**Draft Melbourne Planning Scheme Amendment C407melb  
Arden Structure Plan**

**Advisory Committee Report**

**2 May 2022**

**Figure 7: Quantum of floor space proposed**

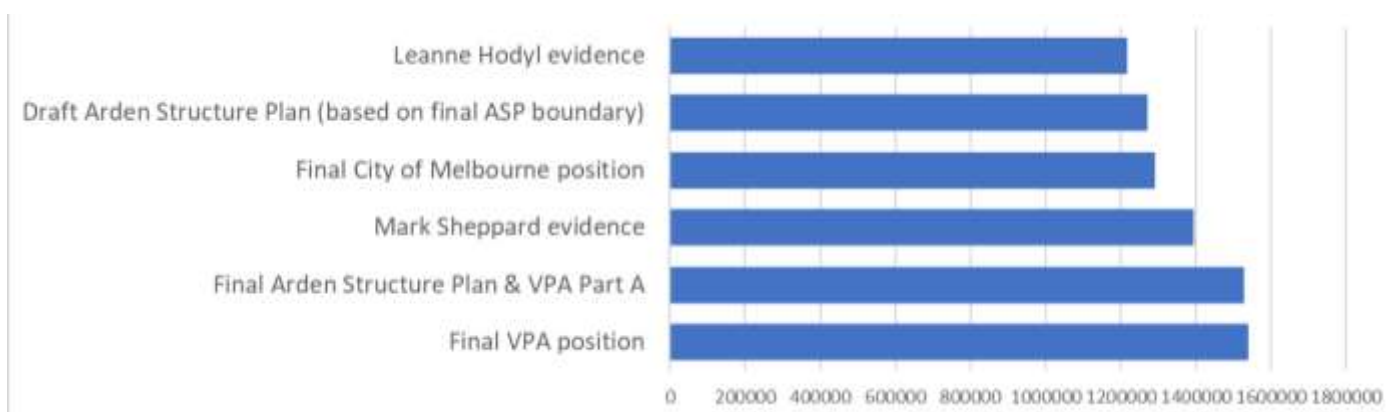
Figure 7 shows that extent in variation of the quantum of floor space proposed.

Council and the VPA differed on how to calculate the proposed FARs. Council preferred a block by block approach and the VPA preferred a whole of precinct approach. Table 2 shows the average FAR calculated by each of these methods.

Figure 12: Proposed PAO

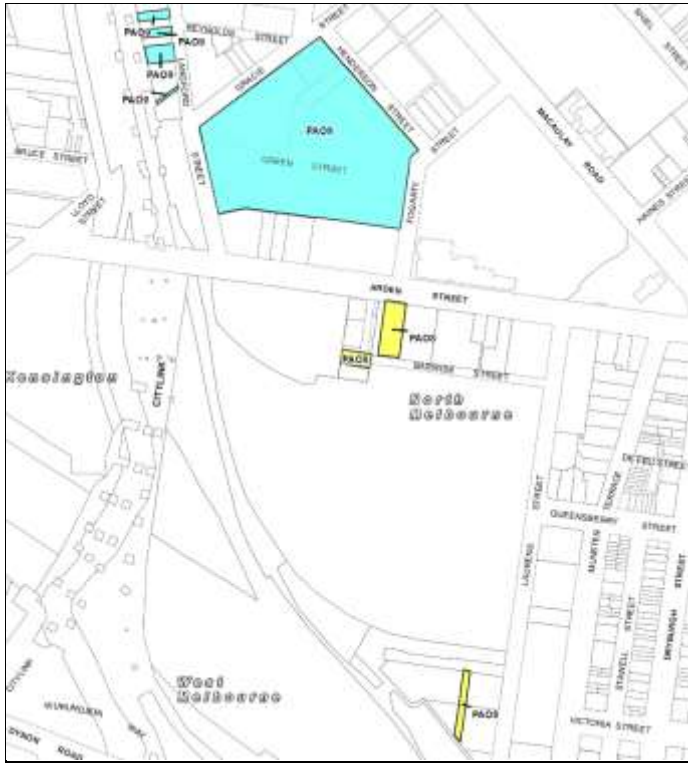
Figure 12 shows the proposed land acquisition, and Table 6 the purpose of the acquisition.

Figure 13: PAO8 on Guntar Graphics land

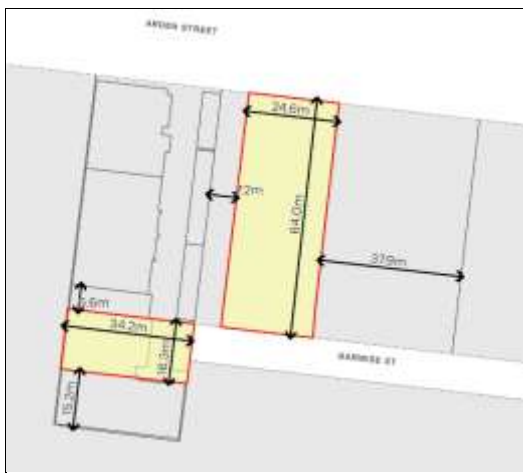
- The location of the PAO location on Guntar Graphics land.

Figure 14: Buffer Area Overlay

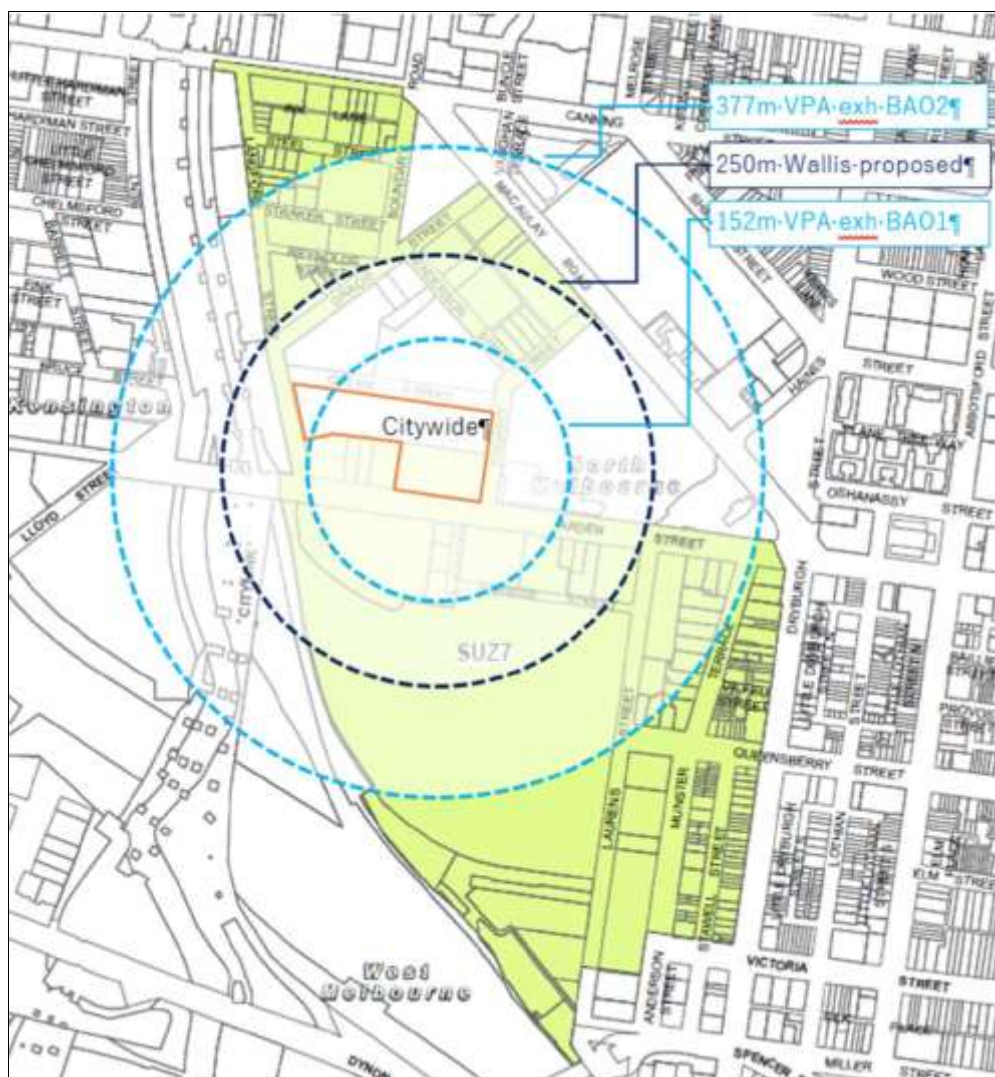
It is proposed to apply two schedules of the BAO, as shown in Figure 14.

Figure 15: DDO80 sub-precinct boundaries and FARS

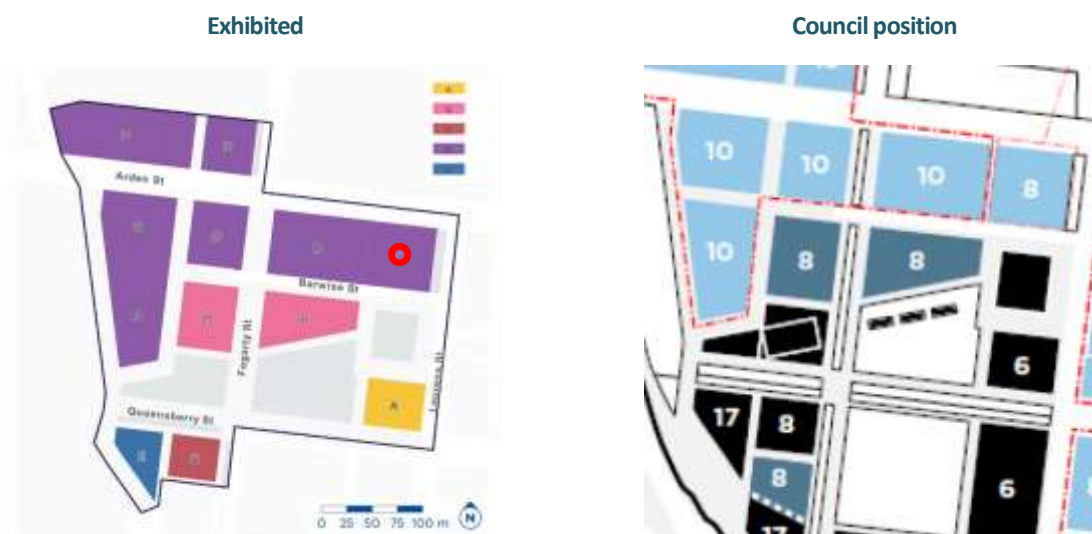
Figure 15 shows the sub-precinct boundaries for the DDO80 area with the final positions of the VPA, Council and experts shown in Table 12.

Area	VPA Submission	Final Mark Sheppard	Leanne Hodyl	Council
DDO80A	6:1 discretionary	6:1 mandatory	6:1 mandatory	6:1 mandatory
DDO80B	8:1 discretionary	8:1 mandatory	8:1 mandatory	8:1 mandatory
DDO80C	8:1 discretionary	8:1 mandatory	8:1 mandatory	8:1 mandatory
DDO80D	12:1 discretionary	10:1 mandatory	10:1 mandatory for commercial buildings 8:1 mandatory for residential buildings 8:1 mandatory for site north of station ●	10:1 mandatory 8:1 mandatory for site north of station
DDO80E	17:1 discretionary	17:1 mandatory	17:1 mandatory	17:1 mandatory

Figure 18: DDO81 sub-precinct boundaries and FARs

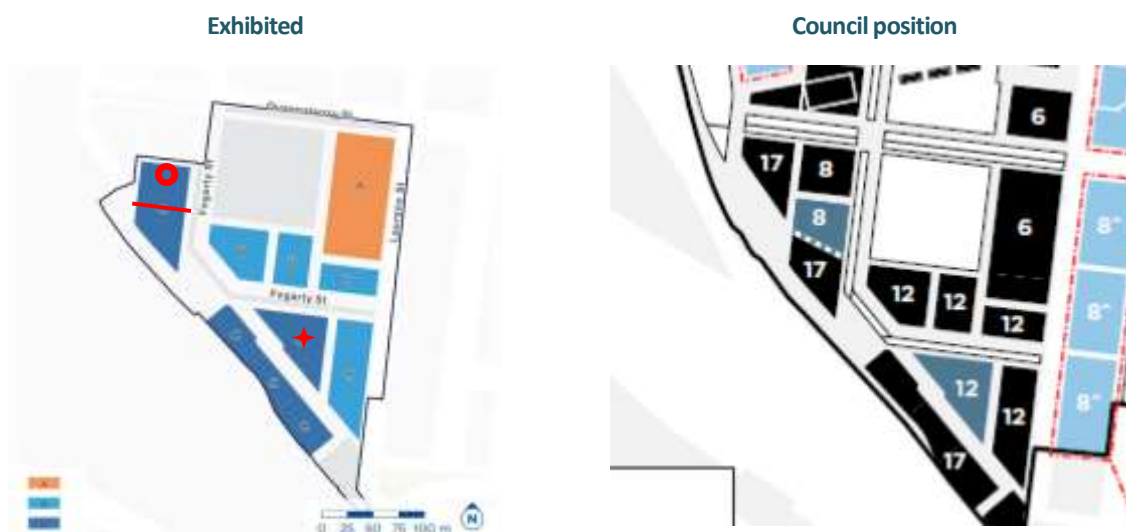
Figure 18 shows the sub-precinct boundaries for DDO81 with the final positions of the VPA, Council and experts shown in Table 15.

Lot	VPA Final Submission	Mark Sheppard	Leanne Hodyl	Council
DDO81A (school)	6:1 discretionary	6:1 mandatory	6:1 mandatory	6:1 mandatory
DDO81B	12:1 discretionary	12:1 mandatory	12:1 mandatory	12:1 mandatory
DDO81C	17:1 discretionary	17:1 mandatory	17:1 mandatory	17:1 mandatory
DDO81C opposite park <span style="color:red">●</span>	17:1 discretionary	8:1 mandatory	8:1 mandatory	8:1 mandatory
DDO81C triangle lot <span style="color:red">★</span>		12:1 mandatory	12:1 mandatory	12:1 mandatory

Figure 19: DCP Projects (Plan 4 of the Arden Development Contributions Plan)

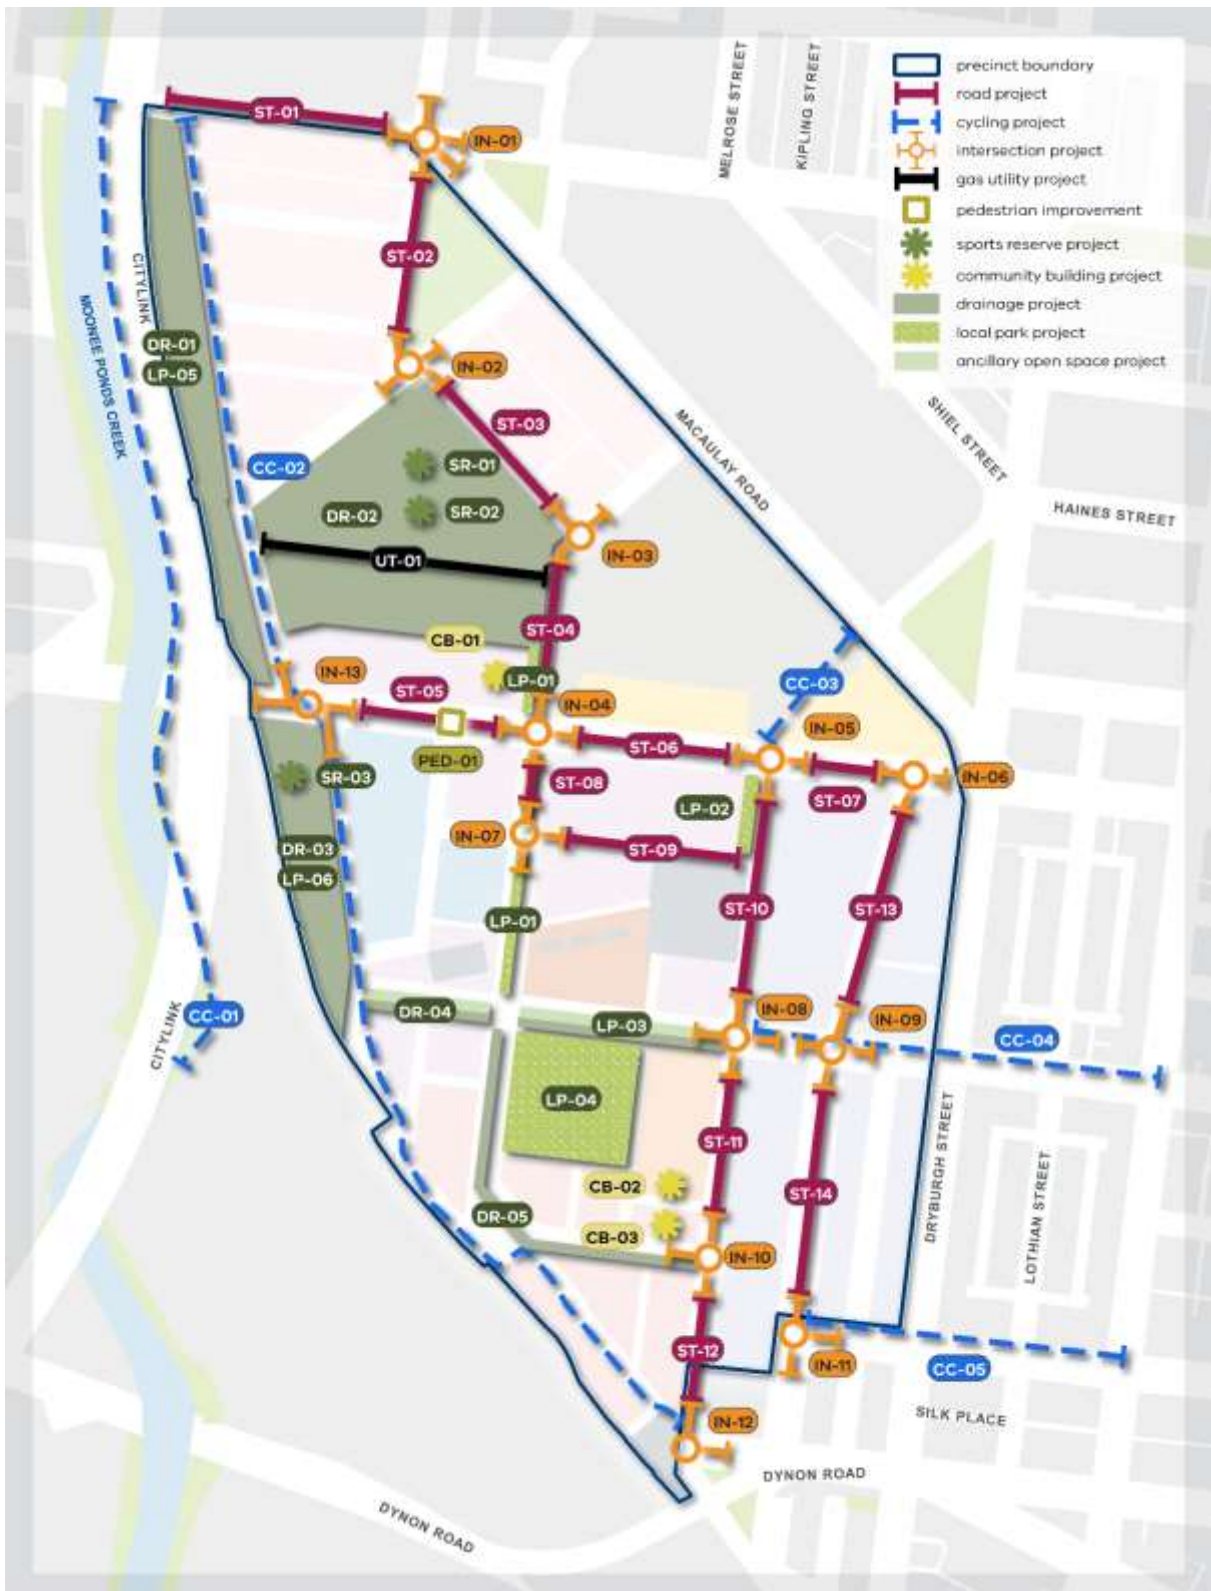
Figure 19 shows the proposed infrastructure items to be included in the DCP.

During the Hearing some errors in the DCP were highlighted by the DCP conclave. These errors were corrected and the subsequent table of costs was tabled by the VPA. These differences are relatively minor and do not affect the discussion below.
